Access Compliance Report

Public Rights-of-Way

(Curb Ramps)

Intersection ID: 14258	Main Street: BERKELEY_AV	Cross Street: LAFAYETTE_AV	Location: NW
ADA ID: A21073486E04	Ramp Type: BlendTrans1	Initial Pass/Fail: Fail	Overall Compliance: No
		Severity Score: 1.25

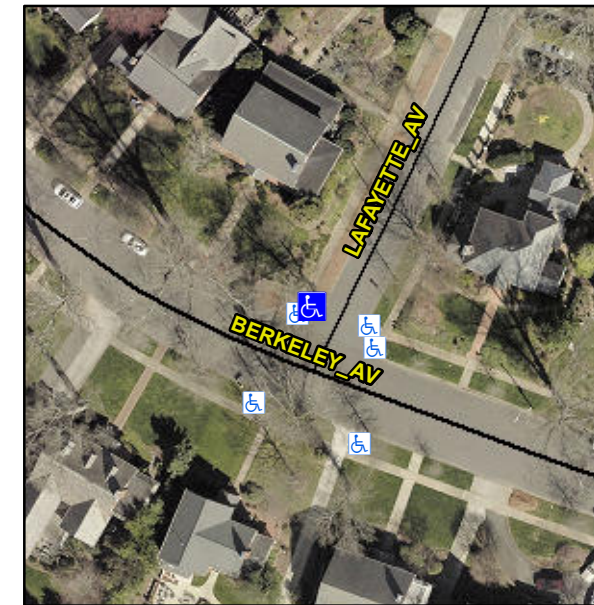
LNDG LIP 2.0

Not Found, R304.5.3

Remove & Replace Curb Ramp With Two New Directional Ramps or Equivalent.
